Subject area A: Accuracy and appropriateness of groundwater category maps

Para 44: Issue: Definition of Category A boundaries is flawed

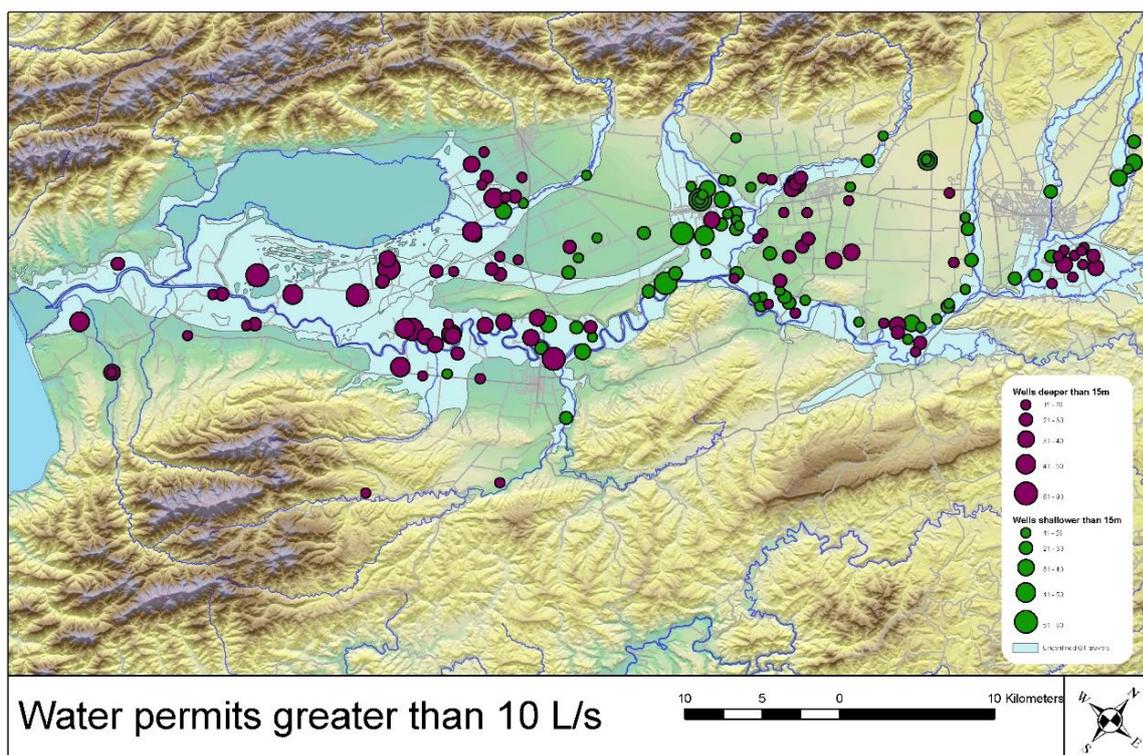
1. Para 44 (JW): Basis for the definition of Category A boundaries was largely based on the spatial extent of Q1 alluvium deposits. He considers this extremely inaccurate.

3. The map below (taken from Jones and Gyopari, 2006) shows that, on a valley-wide scale, the highest permeability ('K') areas, shown in red, are restricted to areas mapped as Q1 alluvium – this is especially evident along the Ruamahanga flats, the Waiohine Plains, Tauherenikau River and in the Te Ore Ore area.

2. *MG response:* Mr Williamson is correct in saying that Q1 alluvium is a mixture of gravels/sands and silts – all river alluvium is. However, he does not acknowledge the very large body of information which shows a strong correlation between aquifer hydraulic conductivity (from bore tests) and bores yields which correlate closely to the Q1 alluvium in the Wairarapa Valley as documented in the technical reports.

5. Combined with the other evidence that Mr Hughes references (pumping test responses, water chemistry and groundwater modelling), this provides a good deal of confidence and justification for using the boundaries of the Q1 alluvium to delineate Category A areas.

7. I therefore cannot agree with Mr Williamson's opinion that the use of Q1 areas to define category A areas is extremely inaccurate.
- **Para 45: Emphasis on observed losses and gain in river flows [for delineating Category A zones]**
